Comparison Report

Item	Old 3CC10550MKW CC (1U,50V,X5R,M,0805,WALSIN)	New 3CC10550K3Y CC (1U,50V,X7R,K,0805)
Size (Inch)	**0805**	**0805**
Brend	Walsin	Walsin
L	2.00 mm ±0.20 mm	2.00 mm ±0.20 mm
W	1.25 mm ±0.20 mm	1.25 mm ±0.20 mm
T	1.25 mm ±0.20 mm	1.25 mm ±0.20 mm
Remark

1. Appearance and Dimensions

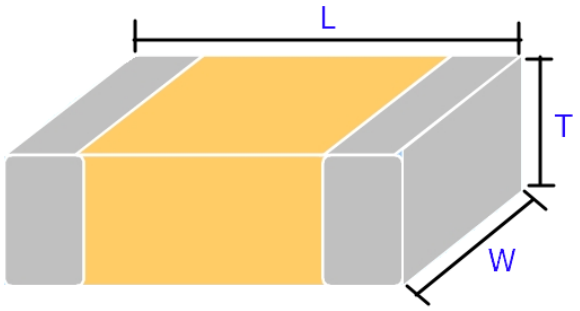
Parameter	(Old)	(New)	Unit
Capacitance	**1**	**1**	**uF**
Rated Voltage	**50**	**50**	**VDC**
Tolerance	**±20**	**±10**	**%**
Dielectric	**X5R**	**X7R**	**-**

This component change has been evaluated by DIVA; the initial successor evaluation showed the new successor is compatible with former model. None of the other components and program will be needed to recalibrate or implement. The ECN will be provided if you approve.
